# Staff Report

**To:** Salt Lake City Planning Commission  
**From:** Amanda Roman, Principal Planner  
[Amanda.Roman@slcgov.com](mailto:Amanda.Roman@slcgov.com) or 385-386-2765 (Cell) / 801-535-7660 (Voicemail)  
**Date:** February 24, 2021  
**Re:** PLNPCM2020-00681 – Reilly Planned Development  
PLNSUB2020-00683 – Reilly Preliminary Subdivision

## PLANNED DEVELOPMENT & PRELIMINARY SUBDIVISION

**PROPERTY ADDRESS:** 1159 E 1300 S  
**PARCEL ID:** 16-08-477-069-0000  
**MASTER PLAN:** Central Community  
**ZONING DISTRICT:** R-1/5,000 Single-Family Residential

### SITE PLAN

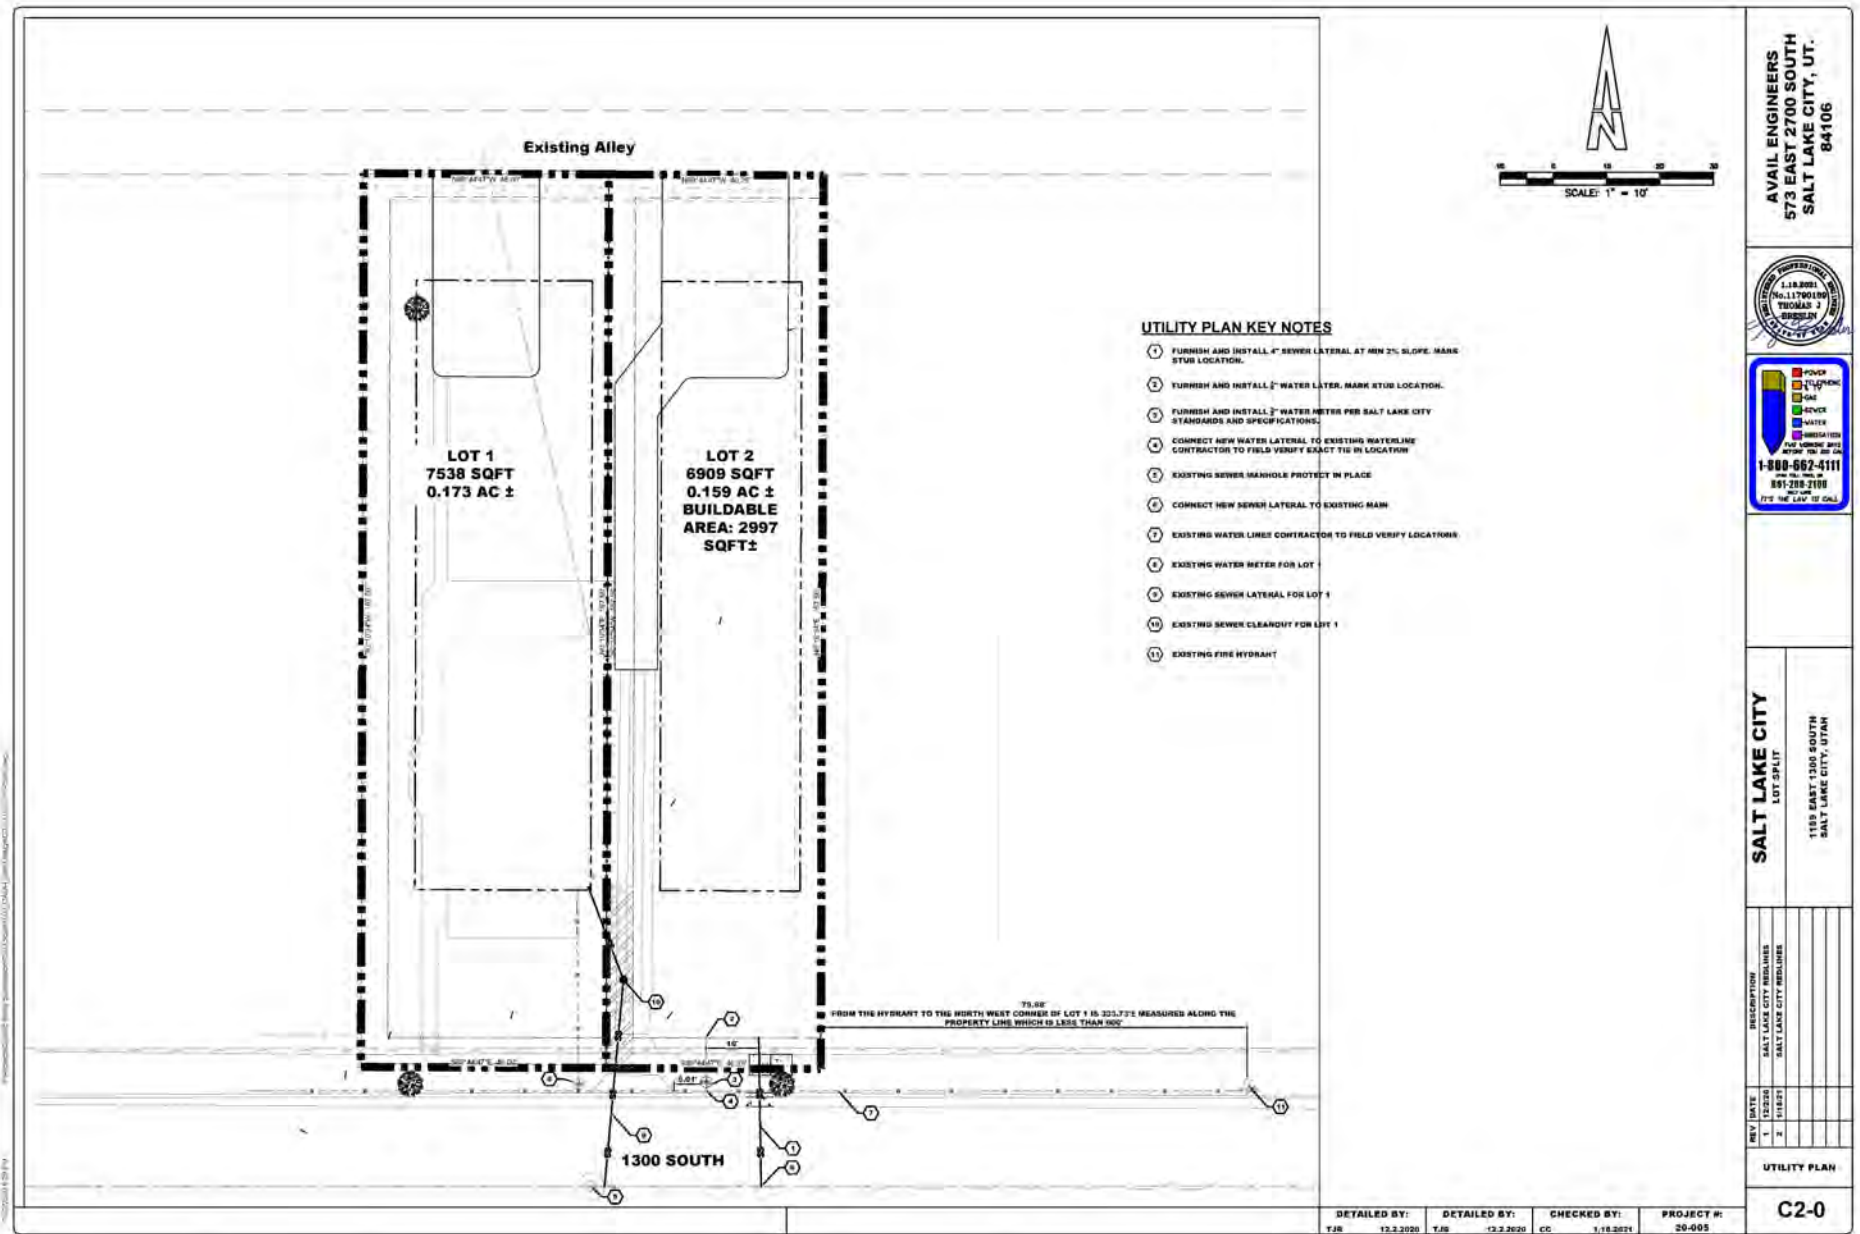
The applicant must show the full dimensions of the concrete parking pads and width of the alley. The driveway onto 1300 South must lead to a properly located parking area; existing and proposed improvement for the driveway should be shown on the plans. The dimensional requirements are located in 21A.44.020. Two parking spaces per lot are required and must be located within the interior side yard or rear yard.

*Planning Response: The applicant revised the civil set to show the alley ROW and two legal off-street parking spaces per lot.*
